**CCL 27/09/16
ENDORSEMENT OF PROPOSED AMENDMENT TO LOCAL ENVIRONMENTAL
PLAN 2012 –RAIL CORRIDOR LAND BETWEEN WORTH PLACE AND WATT
STREET NEWCASTLE**

Attachment D: Urban Design Consultative Group reports from 11 July 2016
and 17 August 2016

Name of Project (if applicable): Rail Corridor Rezoning Associated DCP Guidelines

Attachment E: Master Plan (Urban Growth NSW) and detailed parcel analysis of submitted proposal (NCC August 2016)

Parcel 01

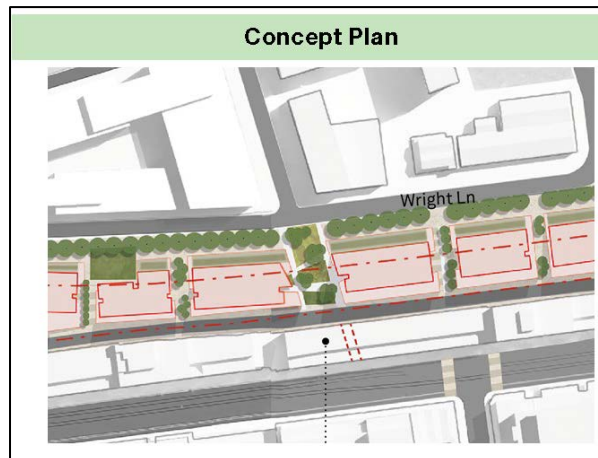
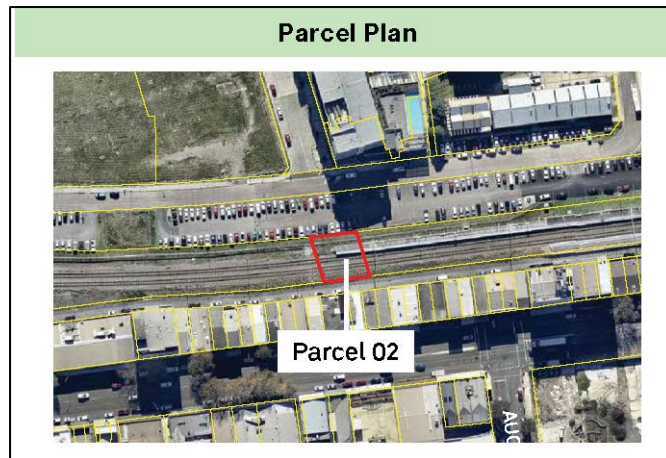
Parcel No. 01	Submitted Proposal (Urban Growth NSW)	Urban Design Consultative Group	Council Planning Proposal (Attachment A)
	Justification • Adjacent to current car park which is likely to be developed in future. • Therefore likely to be amalgamated with land to the north. • Directly adjacent to, and at back of buildings fronting Hunter Street. • Access to Worth Place, Wright Lane and Civic lane. • Opportunities for Mixed Use development.	Recommend maximum height 24m. Test FSR at 2.5:1, having regards to need to achieve Apartment Design Guidelines (ADG) separations, and also possible street widening of Civic Lane and Wright Lane.	In response to UDCG, applicant has provided further justification: • Will be amalgamated north with combined width of approximately 39m, therefore could support good design outcome and meet the Apartment Design Guide. • Civic Lane proposed at 9m and Wright Lane 16m, providing sufficient access. • Overshadowing diagrams indicate minimal amenity impact.

Parcel No. 01	Submitted Proposal (Urban Growth NSW)	Urban Design Consultative Group	Council Planning Proposal (Attachment A)
	Requested LEP amendments • Zone B4 Mixed Use. • Height 30m. • FSR 3:1. Potential yields • Parcel area 3,370m². • Non-residential 1,000m². • Dwellings 110.		<u>Outcome</u> Support the submitted proposal. Retain the height as proposed at 30m as it is agreed that the land is likely to be consolidated with land to the north (up to Wright Lane) which is currently owned by Hunter Development Corporation. This adjoining land is currently a maximum height of 30m, and should ideally be consistent. An analysis of constructed buildings within the vicinity identify that the following are built to approximately 30m. • 18 Honeysuckle Drive (south-west corner of Honeysuckle Drive and Worth Place. • 14 Honeysuckle Drive (Chifley apartments) Therefore a consistent height limit would facilitate compatible forms. The DCP guidelines developed post Gateway would need to detail road and building sections to ensure appropriate built form within the height limit. The shadow analysis indicates shadowing to public open space would be acceptable. Shadowing to individual buildings would need to be assessed in greater detail at the development application stage, as would building separation distances. Proposed LEP amendments • Zone B4 Mixed Use. • Height 30m. • FSR 3:1.

Parcel 02

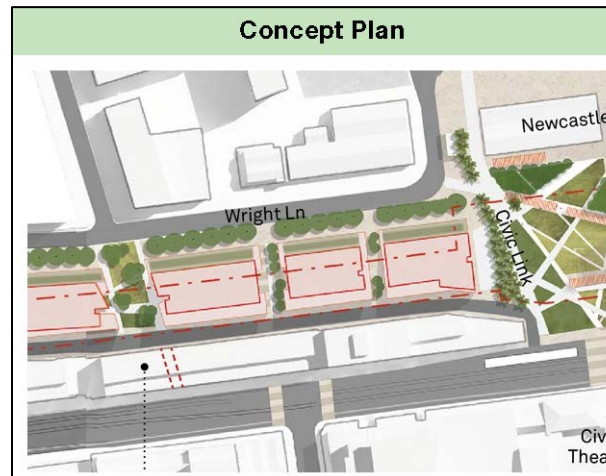
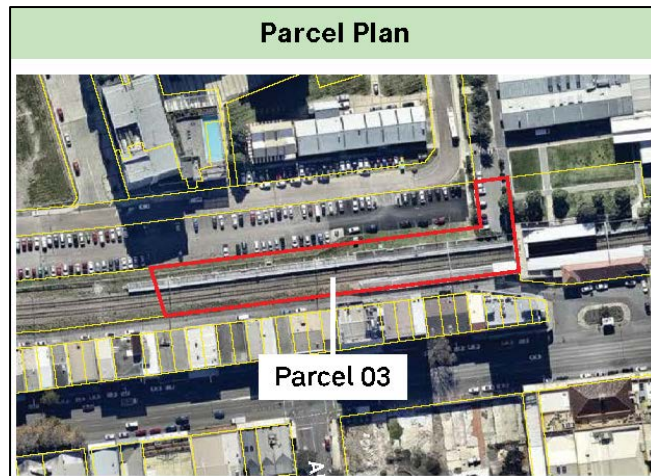
Parcel No. 02	Submitted Proposal (Urban Growth NSW)	Urban Design Consultative Group	Council Planning Proposal (Attachment A)
	Justification • Substantial public realm improvement. • Landscaped pedestrian connection linking Civic and Wright Lane to harbour • Potential future link to Hunter Street. • Potential amalgamation with land to north to form public realm linkage. • Dedication to Council. Requested LEP amendments • Zone B4 Mixed Use • Height 30m. • FSR3:1.	Maximum height 24m.	Support the submitted proposal. Smaller parcels such as these are generally not included in RE1 Public Recreation zone, but rather take surrounding zone and controls. Further work on whether Council would take ownership or whether it should stay part of the private allotment will be undertaken post gateway. Support height at 30m as proposed as this is consistent with adjoining land which is currently a maximum height limit of 30m. The requirement to keep this Parcel for the public connection would be specified under site DCP guidelines developed post Gateway. Note that the Planning Proposal includes acquisition of parcels to the south of Parcel 02 to complete a link between Hunter Street through to the harbour. The funding for such

Parcel No. 02	Submitted Proposal (Urban Growth NSW)	Urban Design Consultative Group	Council Planning Proposal (Attachment A)
	Potential yield - Parcel area 408m². - No buildings proposed.		can be negotiated through a Planning Agreement with Urban Growth NSW.. Proposed LEP amendments - Zone B4 Mixed Use. - Height 30m. - FSR 3:1.

Parcel 03

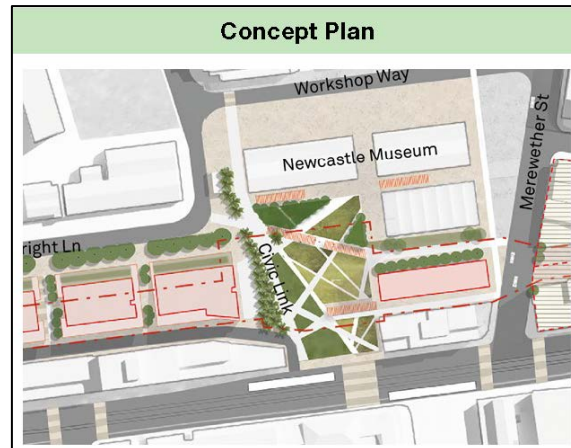
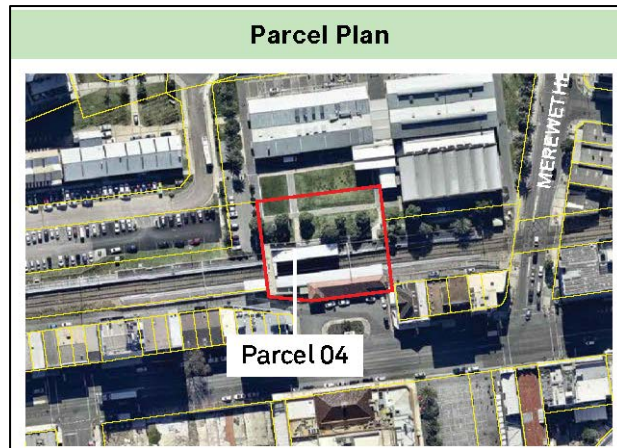
Parcel No. 03	Submitted Proposal (Urban Growth NSW)	Urban Design Consultative Group	Council Planning Proposal (Attachment A)
	Justification - Potential amalgamation between Parcel 3 and land to the north. - Access to Wright Lane and Civic lane. - Proposed mixed use development to compliment Hunter Street and an active edge to Civic Link. - Buildings to the south have their backs to the site thus building likely to orientate northwards. Requested LEP amendments - Zone B4 Mixed Use. - Height 30m. - FSR 3:1.	Maximum height 24m. Test FSR at 2.5:1, having regards to need to achieve ADG separations, and also some street widening of Civic Lane and Wright Lane. Needs to integrate well with adjacent open space. Refer also advice below for Parcel 04.	In response to UDCG applicant has provided further justification similar to Parcel 01, principally that it will be amalgamated with land to the north. <u>Outcome</u> Generally support submitted proposal. The UDCG suggestion of a height reduction to 24m for the eastern portion can be tested post Gateway with the work done on the FSR. The eastern building edge would likely require a lower scale with upper levels set back, to be detailed under DCP guidelines developed post Gateway.

Parcel No. 03	Submitted Proposal (Urban Growth NSW)	Urban Design Consultative Group	Council Planning Proposal (Attachment A)
	Potential yield • Parcel area 3,146m². • Non-residential 1,000m². • Dwellings 100.		Proposed LEP amendments • Zone B4 Mixed Use and RE1 Public Recreation. • Height 30m • FSR 3:1.

Parcel 04

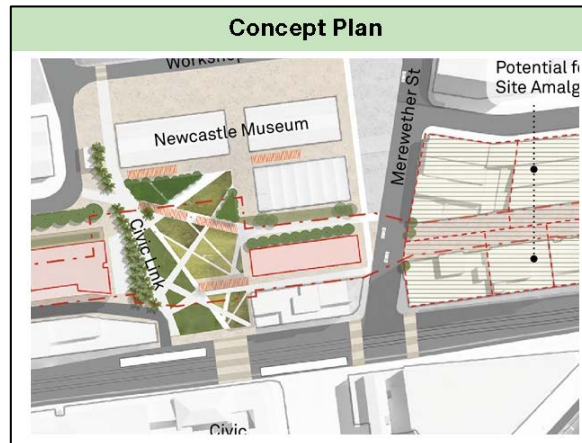
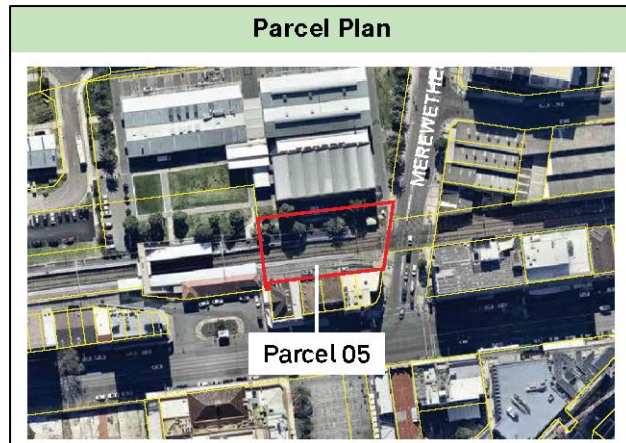
Parcel No. 04	Submitted Proposal (Urban Growth NSW)	Urban Design Consultative Group	Council Planning Proposal (Attachment A)
	Justification - Proposed Civic and public open space. - Significant public domain improvements to compliment Newcastle Museum. - Pedestrian connectivity and through site linkage connecting the Civic Precinct to Honeysuckle and Hunter Street. - Access the parcel from Hunter Street and Wright Lane. Requested LEP amendments - Zone RE1 Public Recreation. - No height or FSR proposed for open space.	Support new open space. Consider in context with proposed adjacent on Parcel 03 due to overshadowing and scale-disjunction.	In response to UDCG applicant has provided further justification indicating acceptable shadow analysis. <u>Outcome</u> Support submitted proposal for additional open space, as the 'Civic Link' concept will provide significant public benefit. Unchanged from submitted proposal. Rationalising the western edge to correspond with Parcel 03 can be detailed with DCP Guidelines post-Gateway. Also proposed to expand proposal north to include the RE1 Public Recreation zone over the open space area at the rear of the Newcastle Museum (this land is not in council ownership), that is currently zoned B4 Mixed Use. These open space areas need to seamlessly integrate and should share the same zone.

Parcel No. 04	Submitted Proposal (Urban Growth NSW)	Urban Design Consultative Group	Council Planning Proposal (Attachment A)
	Potential yield - Parcel area 2,464m². - No development proposed.		The embellishment and dedication of land to Council to be subject of a Planning Agreement. Proposed LEP amendments - Zone RE1 Public Recreation. - No height or FSR proposed for open space.

Parcel 05

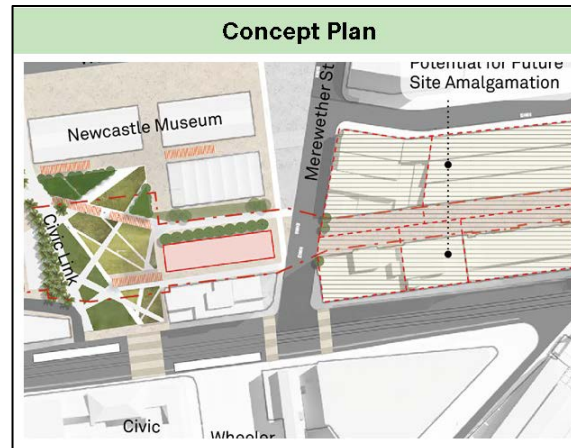
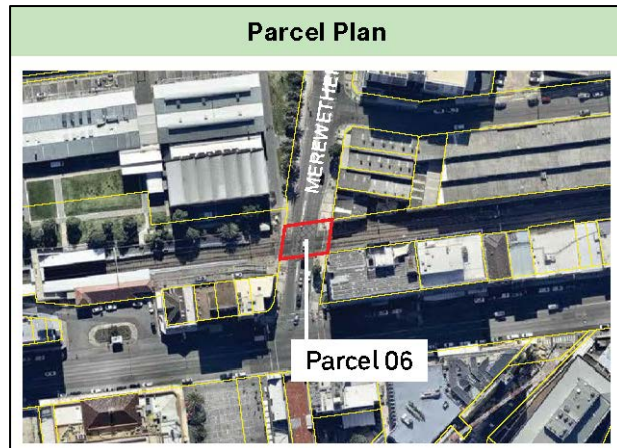
Parcel No. 05	Submitted Proposal (Urban Growth NSW)	Urban Design Consultative Group	Council Planning Proposal (Attachment A)
	Justification - Planning controls consistent with adjacent lot to south to enable amalgamation. - Mixed use development to respect heritage character. - Pedestrian connectivity to and between Merewether Street at eastern extent and public open space at western extent. - Further built form controls proposed to be included in Newcastle DCP. - Access to Merewether Street. Requested LEP amendments - Zone B4 Mixed Use. - Height 24m. - FSR 3:1.	Need to ensure integrates well with adjoining open space.	In response to UDCG applicant has provided further justification: - Parcel is 28.5m wide. - Allows for pedestrian link to Merewether Street. - Adequate setback achievable, including from museum. - Overshadowing acceptable. <u>Outcome</u> The requested height for Parcel 05 is consistent with the adjoining height limit to the south, being 24m. However, the land to the south of Parcel 05 (414 to 426 Hunter Street, Lot 1 & 2 DP18256, Lot 31 & 32 DP534638, Lot 100 DP809262) is being included into the Planning Proposal. The current height limit of 24m is proposed to be reduced to 18m for this land. The current height

Parcel No. 05	Submitted Proposal (Urban Growth NSW)	Urban Design Consultative Group	Council Planning Proposal (Attachment A)
	Potential Yield - Parcel area 1,603m² - non-residential 500m² - Dwellings 45 @ 24m height.		limit of 24m is consistent with that recommended under the Newcastle Urban Renewal Strategy (NURS), noting that the NURS did not alter the height for this location. However, the NURS did not envisage the new 'Civic Link' initiative outlined under the Master Plan which now requires a reinvestigation of the height limit within this location. It is noted that the existing building forms which currently extend up to 18m above ground maintain sunlight at present to Wheeler Place in mid-winter (based upon 32.5 degrees winter sun angle the shadow reaches southern side of road reserve at midday). If these sites were to be redeveloped in the future to the current maximum height limit of 24m this would create more significant overshadowing of Wheeler Place. Given the increased emphasis on the 'Civic Link' concept it is important that these open spaces maintain high levels of amenity. This could be achieved with a reduced height limit to 18m. Having regards to the above the height limit for Parcel 05 is also proposed to be reduced to 18m. This would provide a more compatible scale for the combined block and also ensure minimal overshadowing of Wheeler Place and the 'Civic Link'. A height reduction to 18m would also produce more appropriately scaled development to relate to the adjoining heritage listed museum, which extends to 13m above ground, along with providing a more human scaled edge to the 'Civic Link'. It is anticipated that a lower scale to the edge of 'Civic Link' with upper levels setback, will be

Parcel No. 05	Submitted Proposal (Urban Growth NSW)	Urban Design Consultative Group	Council Planning Proposal (Attachment A)
			detailed under DCP guidelines developed post Gateway. The pedestrian connections from the 'Civic Link' to Merewether Street, as per the Master Plan, would also be detailed in DCP guidelines developed post Gateway. Proposed LEP amendments • Zone B4 Mixed Use • Height 18m • FSR 3:1

Parcel 06

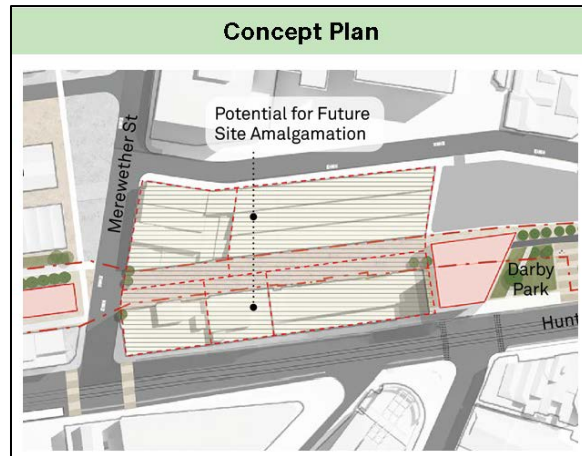
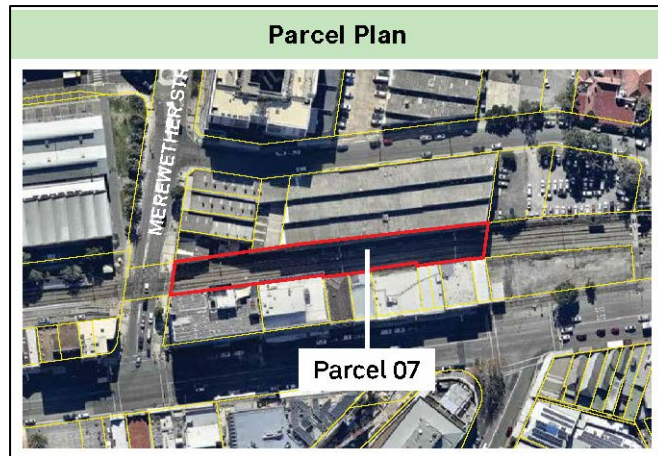
Parcel No. 06	Submitted Proposal (Urban Growth NSW)	Urban Design Consultative Group	Council Planning Proposal (Attachment A)
	Justification - Formalise existing road access between Hunter Street and Merewether Street. - Access to Hunter Street and Merewether Street. - Dedication to Council. Requested LEP amendments - Zone B4 Mixed Use - Height 30m - FSR 2.5:1 Potential Yield - Parcel area 295m² - No development (road).	No comments as this is road.	Support submitted proposal. Roads apply equivalent zoning and controls from adjoining land. Proposed LEP amendments - Zone B4 Mixed Use - Height 30m - FSR 2.5:1

Parcel 07

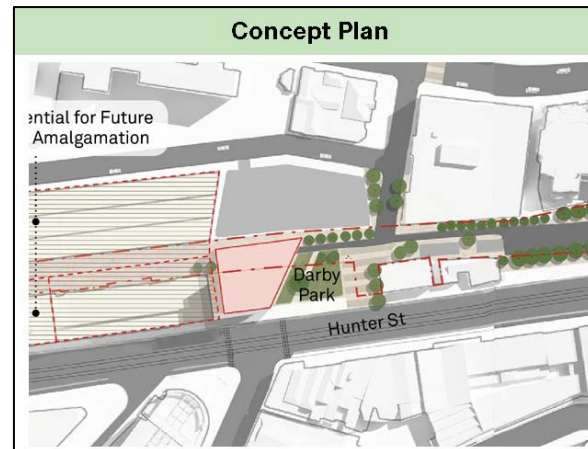
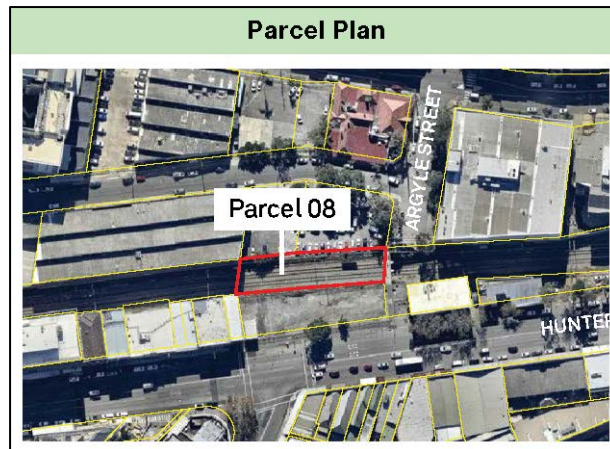
Parcel No. 07	Submitted Proposal (Urban Growth NSW)	Urban Design Consultative Group	Council Planning Proposal (Attachment A)
	Justification - Proposed mixed use development. - Proposed planning controls consistent with adjacent lot to the north to allow amalgamation. - Built for controls in the DCP. - Access to Merewether Street. Requested LEP amendments - Zone B4 Mixed Use - Height 30m - FSR 2.5:1 Potential yield - Parcel area 2,040m² - Non-residential 500m² - Dwellings 55.	Reduce height to 24m, and adjust FSR as required (test FSR2.5:1).	In response to UDCG applicant has provided further justification: - Parcel is 15m wide and unlikely built as an isolated site. - Likely to be amalgamated with land to north. <u>Outcome</u> Support submitted proposal. The corridor within this location is approximately 15m wide meaning that the extent of future development within this Parcel is quite constrained, and would unlikely to be developed as an individual parcel. It is more probable to consolidate with adjoining land to the north, as this land is in single ownership. Therefore it is considered more appropriate to apply consistent controls of 30m and FSR 2.5:1 as already apply to the north.

Parcel No. 07	Submitted Proposal (Urban Growth NSW)	Urban Design Consultative Group	Council Planning Proposal (Attachment A)
			It is noted that the Newcastle DCP 2012 would require as a minimum, a 6m setback from the rear boundary of the buildings fronting Hunter Street. Should residential development be proposed this distance would increase further in accordance with the Apartment Design Guide, up to at least 9m. The corridor within this location is approximately 15m wide meaning that the extent of future development within this parcel, in any regard, will be somewhat limited. Proposed LEP amendments • Zone B4 Mixed Use • Height 30m • FSR 2.5:1

Parcel 08

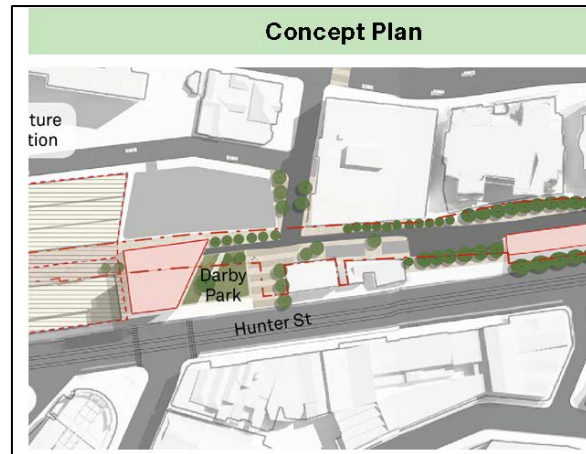
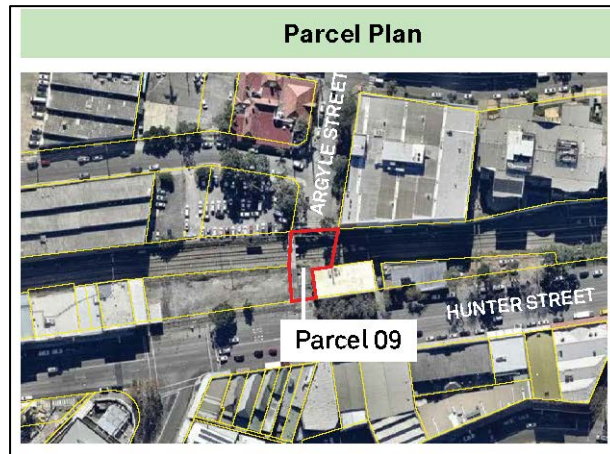
Parcel No. 08	Submitted Proposal (Urban Growth NSW)	Urban Design Consultative Group	Council Planning Proposal (Attachment A)
	Justification - Proposed mixed use development that can be amalgamated with the lot to the south. - Proposed planning controls are the same as the lot to the south to assist amalgamation. - Adjacent to 'Darby Plaza' providing surveillance of space and activation opportunities. - Access to Hunter Street and Argyle Street. Requested LEP amendments - Zone B4 Mixed Use - Height 24m - FSR 4:1	The 'Darby Plaza' concept was supported and ideally land to north would be developed in such a manner to improve connections through to harbour.	Support submitted proposal. The proposed 'Darby Park' falls partly onto this Parcel and would need to be detailed under DCP guidelines developed Post Gateway. The requested FSR at 4:1 may potentially be difficult to achieve due to restricted building footprint to achieve the 'Darby Park'. Through the investigation of DCP controls the FSR may require further refinement post Gateway. This site combined with the adjoining site to the south (on Hunter Street) is included on the key sites map to ensure a high degree of design excellence would be achieved for the 'Darby Park'.

Parcel No. 08	Submitted Proposal (Urban Growth NSW)	Urban Design Consultative Group	Council Planning Proposal (Attachment A)
	Potential yield - Parcel area 988m² - Non-residential 200m² - Dwellings 25		Proposed LEP amendments - Zone B4 Mixed Use - Height 24m - FSR 4:1

Parcel 09

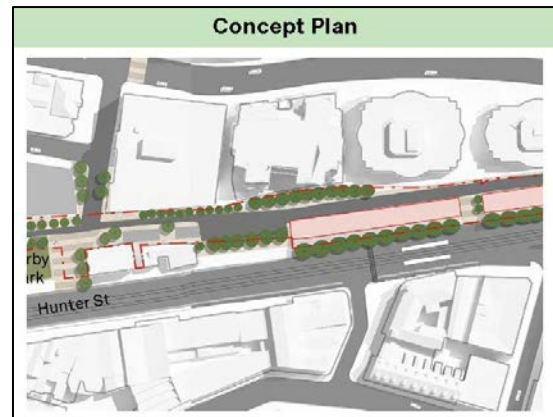
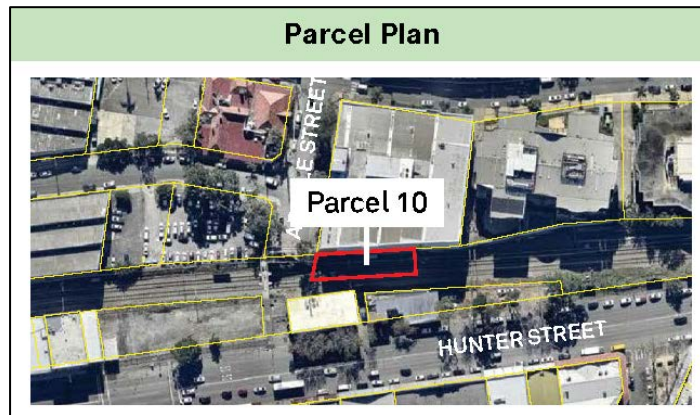
Parcel No. 09	Submitted Proposal (Urban Growth NSW)	Urban Design Consultative Group	Council Planning Proposal (Attachment A)
	Justification • Creation of new public realm linkage and visual connection between the city and Honeysuckle. • Pedestrian linkage to Argyle Street. • Significant public realm improvements. • Provide access to Hunter Street and Argyle Street. • Adjacent proposed developments can activate the area and provide surveillance. • Part of this parcel on the east will provide access laneway to Parcel 10 and 11.	The 'Darby Plaza' concept was supported and ideally land to north would be developed in such a manner to improve connections through to harbour.	Support submitted proposal It is noted that the open space requirements to achieve the 'Darby Park', along with any vehicular access from Argyle Street to rear of Parcel 11, would need to be detailed in the DCP guidelines developed post Gateway. Proposed LEP amendments • Zone B4 Mixed Use • No height or FSR

Parcel No. 09	Submitted Proposal (Urban Growth NSW)	Urban Design Consultative Group	Council Planning Proposal (Attachment A)
	Requested LEP amendments • Zone B4 Mixed Use • No height or FSR Potential yield • Parcel area 467m² • No development proposed.

Parcel 10

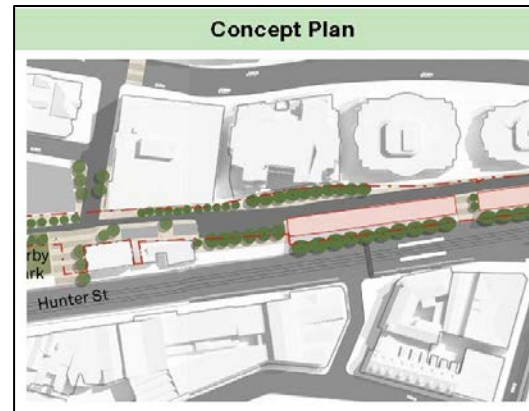
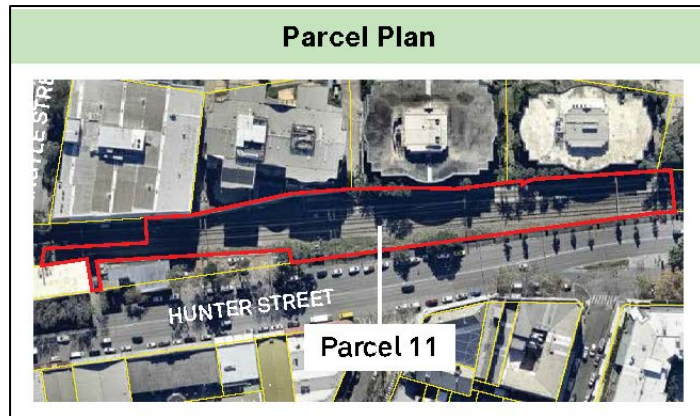
Parcel No. 10	Submitted Proposal (Urban Growth NSW)	Urban Design Consultative Group	Council Planning Proposal (Attachment A)
	Justification - Parcel 10 is not to be rezoned but will retain the current SP2 zoning - Site is to be used for infrastructure and utility purposes, particularly associated with the light rail.	No comment.	Support submitted proposal. Propose as SP2 Infrastructure (Electricity Generating Works Facility)
